State of New Mexico
Energy, Minerals and Natural Resources

WELL API NO.	30 025 08319
5. Indicate Type of Lease	STATE ☒ FEE ☐
6. State Oil & Gas Lease No.	E-6622
7. Lease Name or Unit Agreement Name	North El Mar Unit
8. Well Number	55
9. OGRID Number	20077
10. Pool name or Wildcat	El Mar (Delaware)

SUNDRY NOTICES AND REPORTS ON WELLS
(DO NOT USE THIS FORM FOR PROPOSALS TO DRILL OR TO DEEPEN OR PLUG BACK TO A DIFFERENT RESERVOIR. USE "APPLICATION FOR PERMIT" (FORM C-101) FOR SUCH PROPOSALS.)

Propose to permanently P&A as follows:

Before Plugging

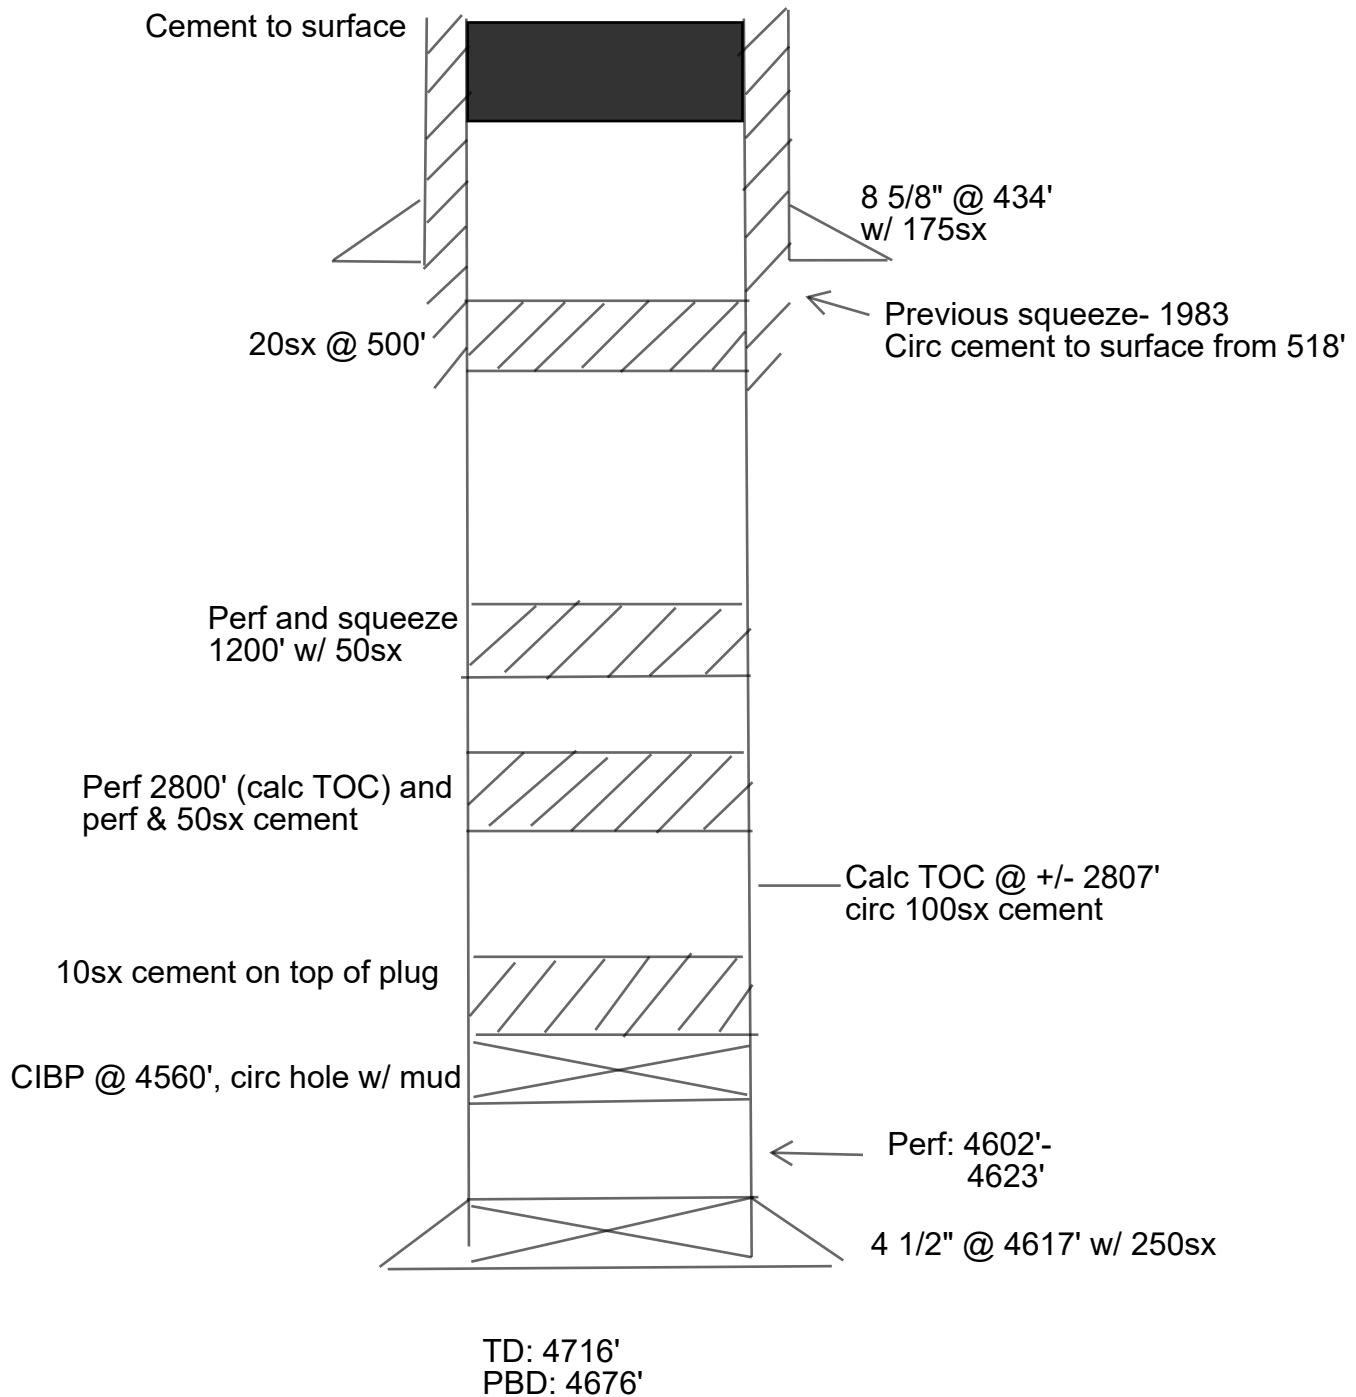
Verify cmt to surface on all casings

MUST BE PLUGGED BY 5/1/25

Created By	Condition	Condition Date
gcordero	CBL must be submitted to OCD via OCD Permitting prior to submitting C-103P	8/2/2024
